IOWA
DEPARTMENT OF TRANSPORTATION
Project Development Division
PLANS OF PROPOSED IMPROVEMENTS ON THE
PRIMARY ROAD SYSTEM
MUSCATINE COUNTY
BRIDGE PAINTING
ON IA 92 OVER
MISSISSIPPI RIVER & R.R.

REVISED: 5-14-97; BEAM END REPAIRS, HANDHOLE TREATMENT AND RETROFIT DETAILS MODIFIED. SEE SHEETS 3, 5, 6, 7, 8, 13, 14, 15 AND 16 OF 16.

LISTING OF PROJECT REVISIONS

DATE	SHEET NUMBER	DESCRIPTION OF REVISIONS	DATE	SHEET NUMBER	DESCRIPTION OF REVISIONS
5-15-97	1A OF 16	REVISION SHEET ADDED.			
	3 OF 16	VARIOUS QUANTITIES CHANGED.			
	5 OF 16	REPAIR LOCATIONS MODIFIED.			
	6 & 7 OF 16	REPAIR LOCATIONS MODIFIED. END PATCH REPAIR PROCEDURE ADDED.			
	8 & 13 OF 16	NOTES MODIFIED.			
	14 OF 16	RETROFIT LOCATIONS MODIFIED.			
	15 & 16 OF 16	NOTES MODIFIED.			
5-15-97		REASON: PREBID CONFERENCE DISCUSSION AND ADDITIONAL FIELD INFORMATION.

PLAN VIEWS SHOWING REPAIR LOCATIONS

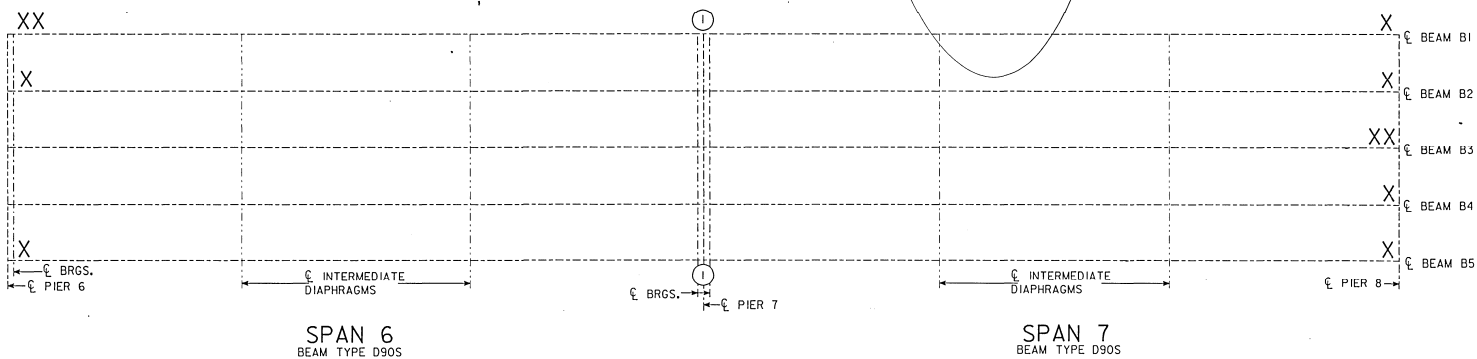
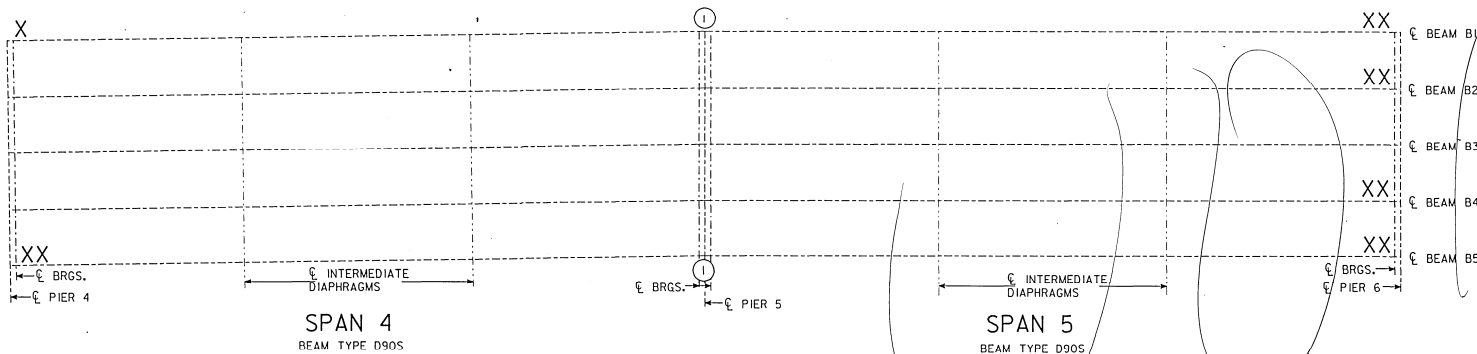
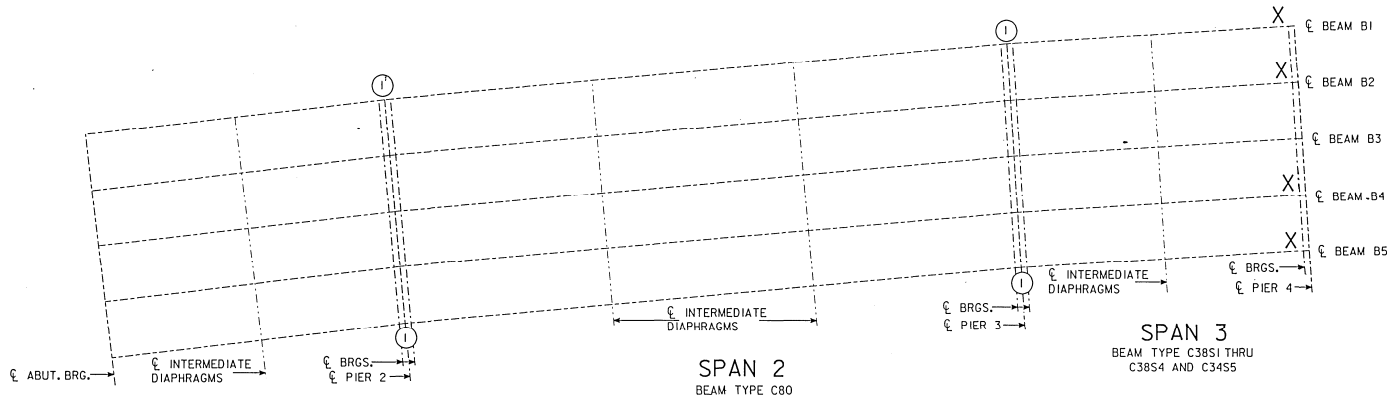
REVISED : 5-14-97 : REPAIR LOCATIONS MODIFIED.

PLAN VIEWS SHOWING REPAIR LOCATIONS

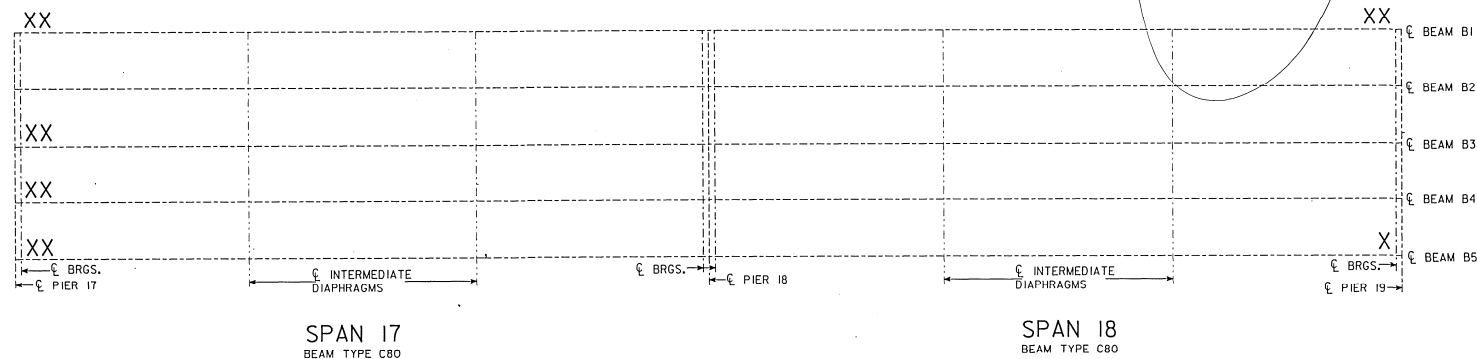
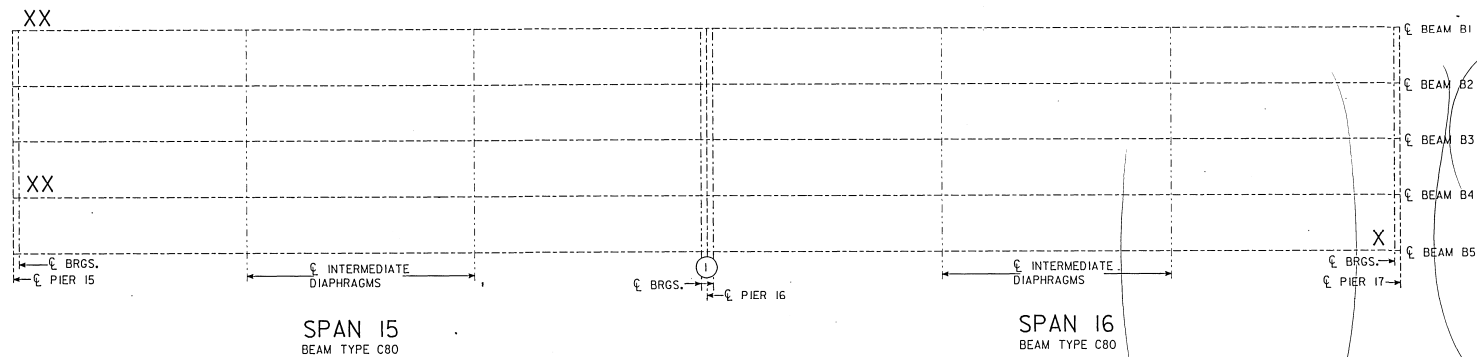
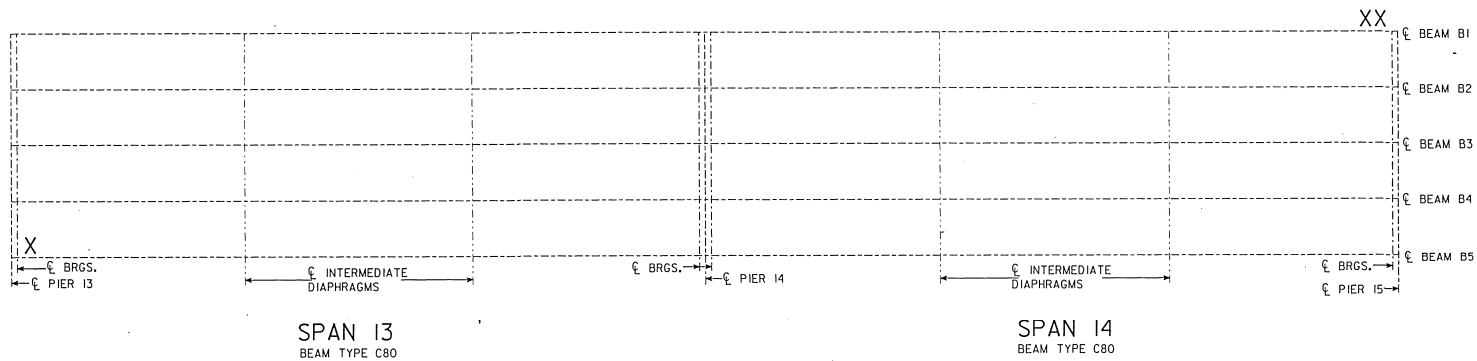
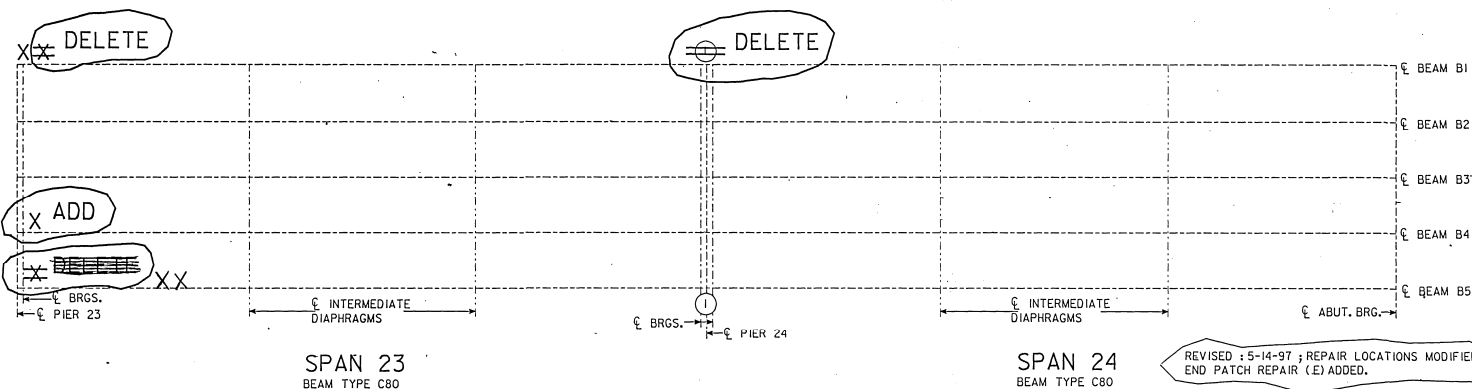
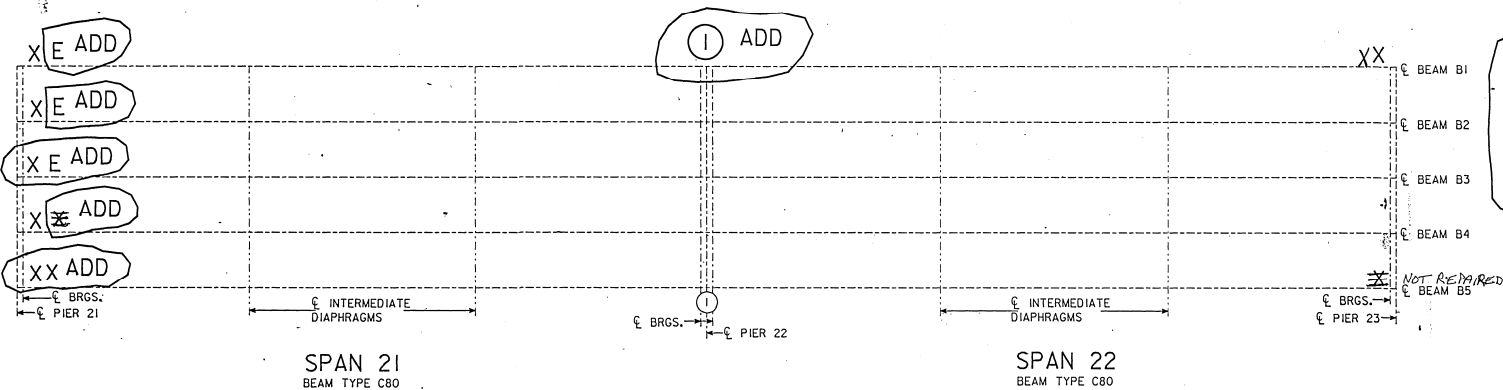
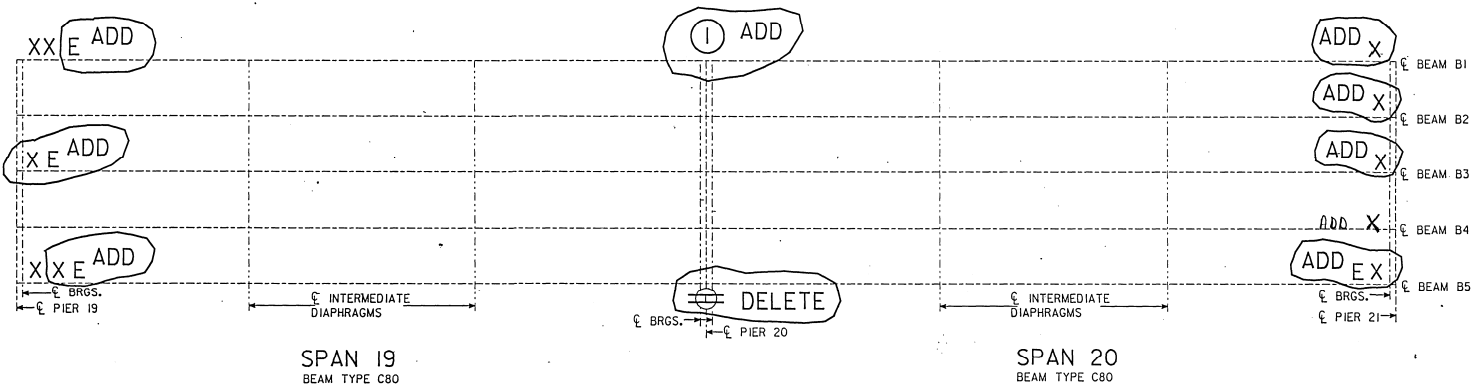
REVISED : 5-14-97 : REPAIR LOCATIONS MODIFIED,
END PATCH REPAIR (E) ADDED.

E = END PATCH REPAIR
(REMOVE EXISTING PATCH &
REPLACE WITH MASTER BUILDERS
EMACO P22 OR SIKATOP ARMATEC
110 WITH A FINISH COAT OF
SIKATOP 123 PLUS)

PLAN VIEWS SHOWING REPAIR LOCATIONS

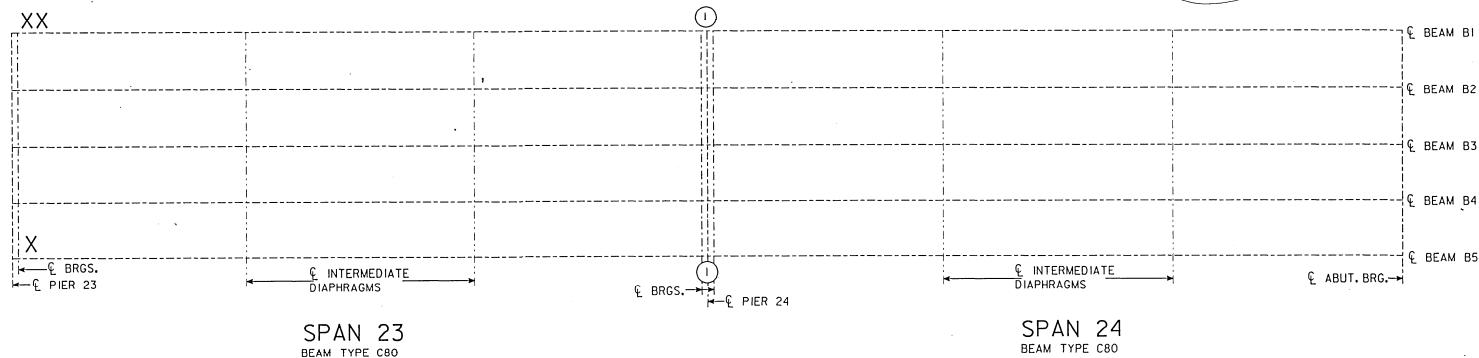
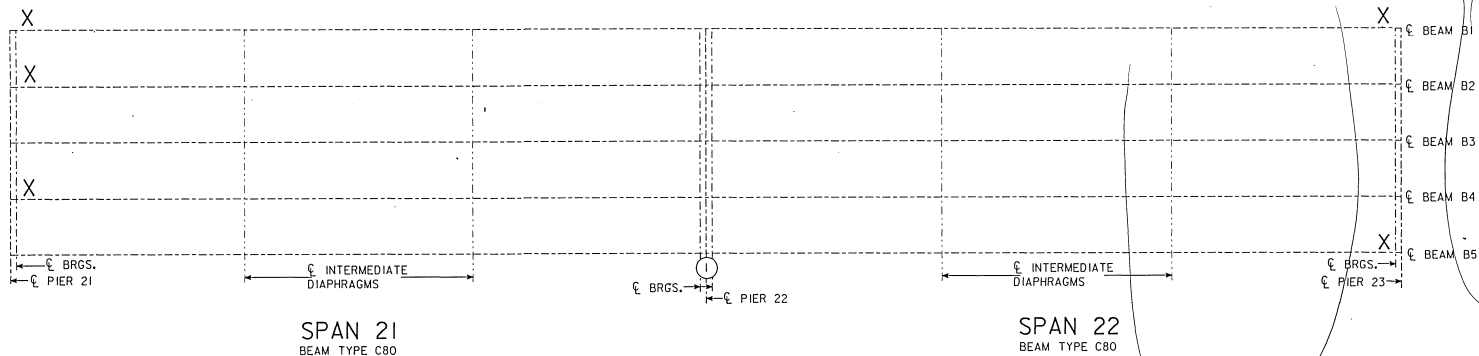
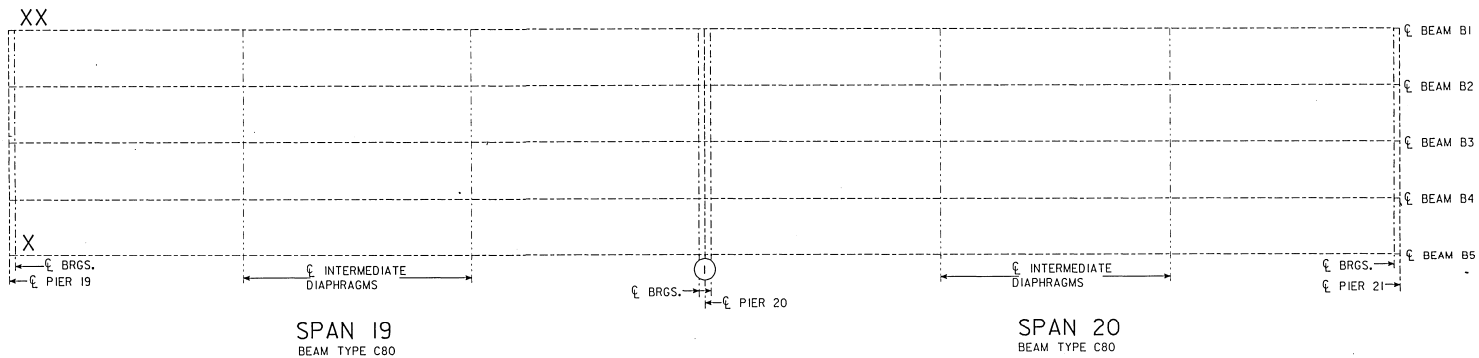
REVISED : 5-14-97 ; REPAIR LOCATIONS MODIFIED.
END PATCH REPAIR (E) ADDED.

DESIGN FOR REPAIRS TO
MISSISSIPPI RIVER BRIDGE
AT
MUSCATINE IOWA
BEAM END REPAIR DETAILS & NOTES
FEBRUARY, 1997
MUSCATINE COUNTY
IOWA DEPARTMENT OF TRANSPORTATION - PROJECT DEVELOPMENT DIVISION
DESIGN SHEET NO. 6 OF 14 FILE NO. 29148 DESIGN NO. 197

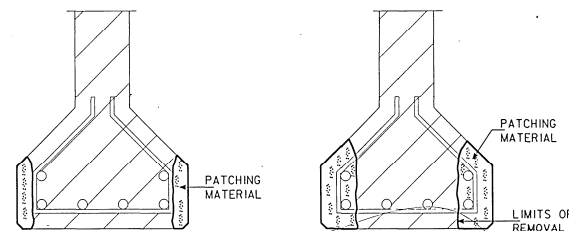
DELETE

REPLACE

REVISED : 5-14-97 ; NOTES MODIFIED.

ADD :
REMOVAL WILL INCLUDE
EXISTING EPOXY PATCHING
MATERIAL AT BEAM ENDS
WHERE SPECIFIED

ADD : SIKAREPAIR 123 PLUS OR MASTER BUILDERS MASTERPATCH 230 VP

5. SANDBLAST 6 FEET OF THE ENDS OF THE REPAIRED BEAMS AS SHOWN ON THIS SHEET. THE SANDBLASTING SHALL BE A LIGHT BLAST JUST ENOUGH TO EXPOSE THE FINE AGGREGATES. ALL COSTS ASSOCIATED WITH SANDBLASTING IS TO BE INCLUDED IN THE PRICE BID FOR "REPAIR BEAM ENDS".

DESIGN FOR REPAIRS TO
MISSISSIPPI RIVER BRIDGE
AT
MUSCATINE IOWA
HANDHOLE SCREEN MODIFICATION DETAILS
FEBRUARY, 1997
MUSCATINE COUNTY
IOWA DEPARTMENT OF TRANSPORTATION - PROJECT DEVELOPMENT DIVISION
DESIGN SHEET NO. 11 OF 14 FILE NO. 29148 DESIGN NO. 197

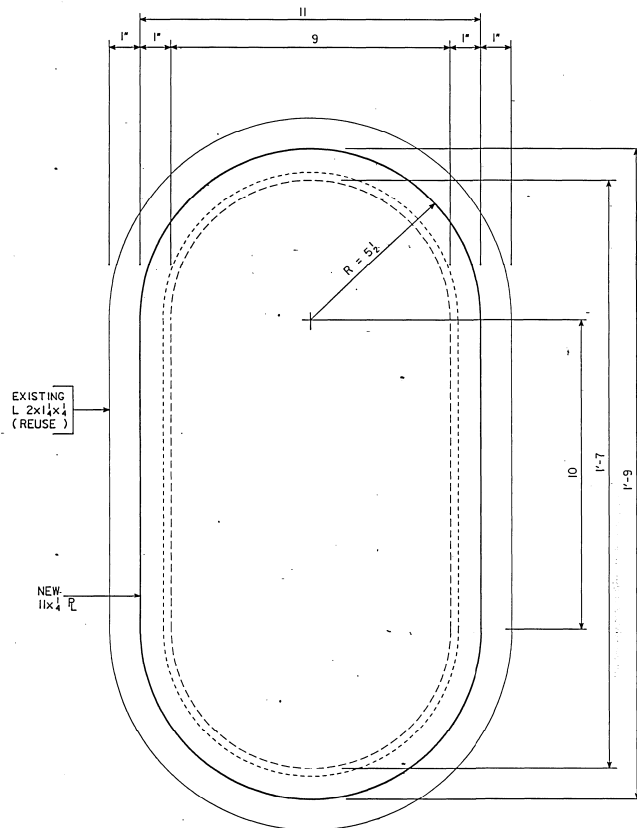
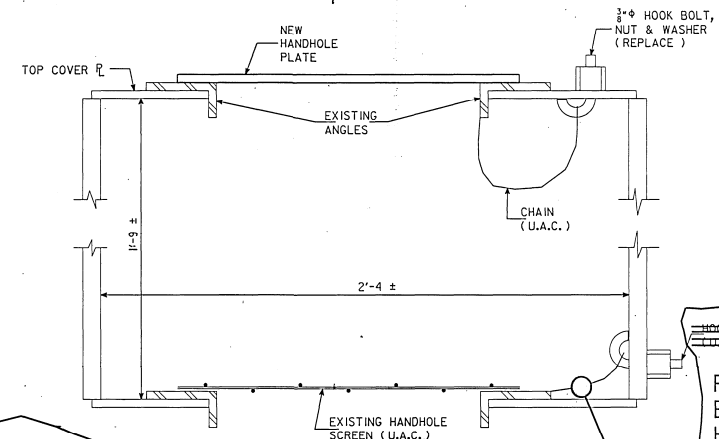
DELETE

REVISED : 5-14-97 ; NOTES MODIFIED.

ADD :
3. CLEAN EXISTING CHAIN & ANGLE BEFORE RE-GALVANIZING. A NEW CHAIN MAY BE USED IF THE CONTRACTOR ELECTS TO DO SO.

ADD :
5. GALVANIZE NEW PLATE AND THE ANGLE & CHAIN.

ADD :
CONNECT EXISTING CHAIN TO THE HOOK BOLT IN THE TOP COVER PLATE. PROVIDE ADDITIONAL CHAIN AS NEEDED.

DESIGN FOR REPAIRS TO
MISSISSIPPI RIVER BRIDGE
AT
MUSCATINE IOWA
RETROFIT DETAILS-STEEL GIRDER SPANS
FEBRUARY, 1997
MUSCATINE COUNTY
IOWA DEPARTMENT OF TRANSPORTATION - PROJECT DEVELOPMENT DIVISION
DESIGN SHEET NO. 12 OF 14 FILE NO. 29148 DESIGN NO. 197

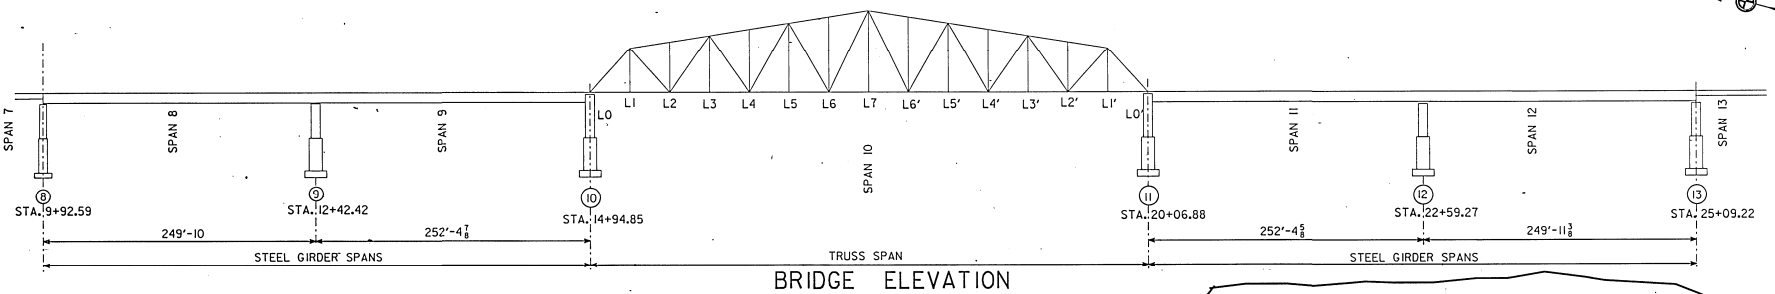
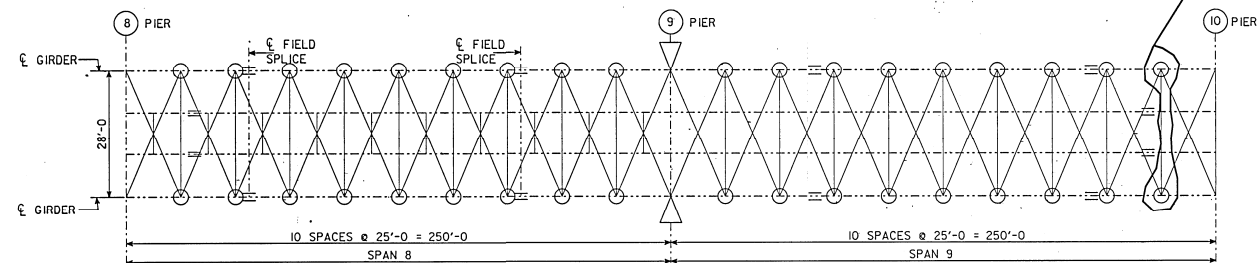
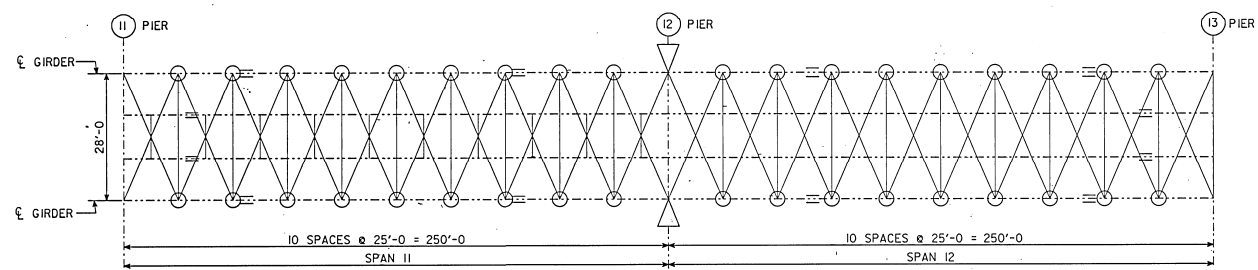
THESE WERE INSTALLED AS SAMPLES ON 4-7 & 4-8-97.

REVISED : 5-14-97 ; RETROFIT LOCATIONS MODIFIED.

DESIGN FOR REPAIRS TO
MISSISSIPPI RIVER BRIDGE
AT
MUSCATINE IOWA
GIRDER RETROFIT DETAIL

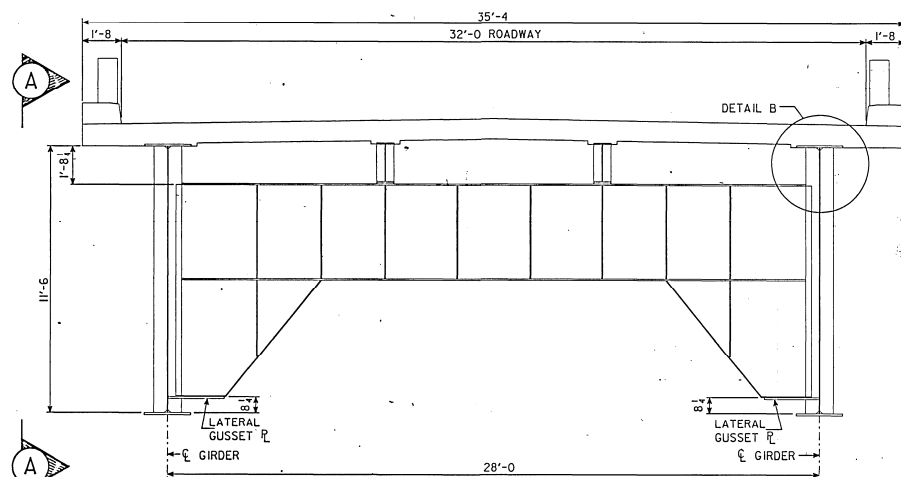
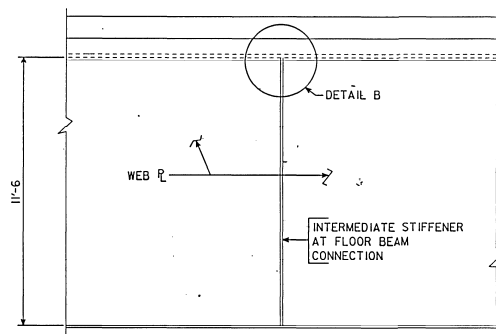
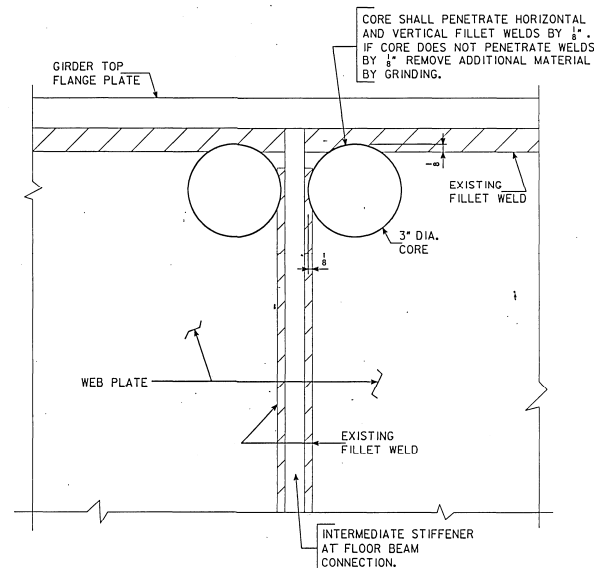
DELETE

DELETE

~~TRAFFIC WILL BE RESTRICTED TO THE OPPOSITE SIDE OF THE BRIDGE DECK DURING RETROFITTING OPERATION. REFER TO THE TRAFFIC CONTROL PLAN FOR APPROPRIATE TRAFFIC SETUPS.~~

REVISED : 5-14-97; NOTES MODIFIED.

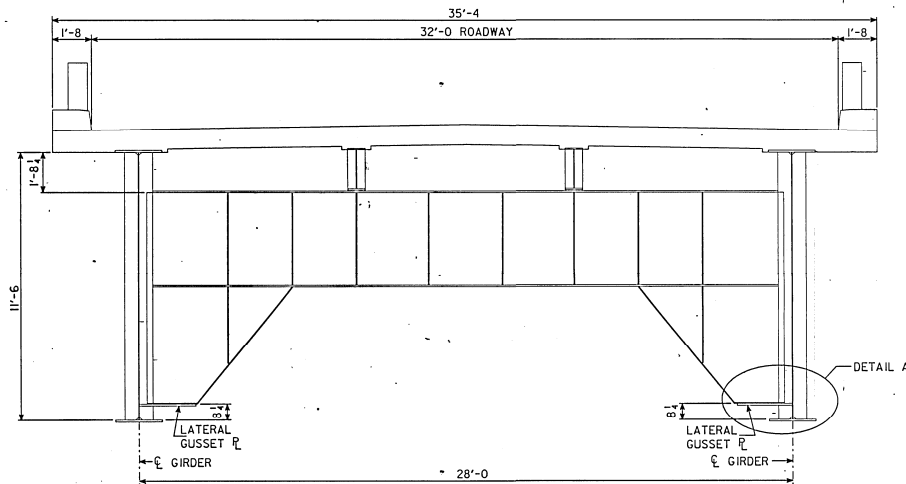
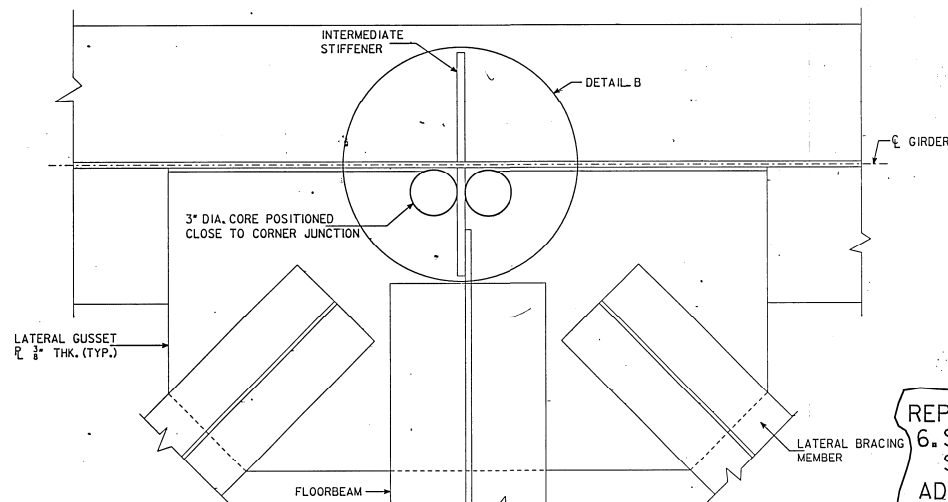
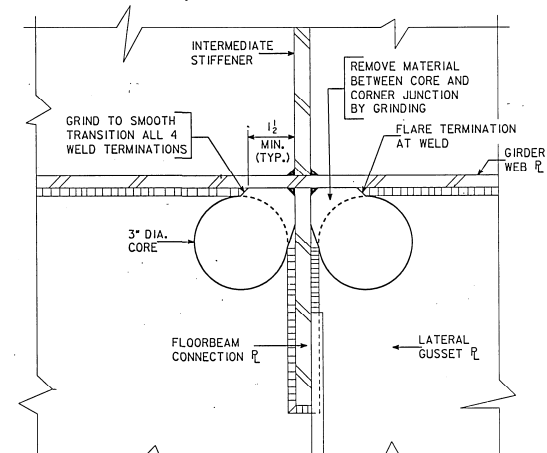
~~TRAFFIC WILL BE RESTRICTED TO THE OPPOSITE SIDE OF THE BRIDGE DECK DURING RETROFITTING OPERATION. REFER TO THE TRAFFIC CONTROL PLAN FOR APPROPRIATE TRAFFIC SETUPS.~~

DELETE

DELETE

REVISED : 5-14-97, NOTES MODIFIED.

REPLACE
6. SHARP CORNERS AT THE DRILLED HOLES SHALL BE GROUND DULL TO HOLD PAINT.
ADD
8. NO TORCHWORK WILL BE ALLOWED FOR GUSSET PLATE RETROFIT WORK.
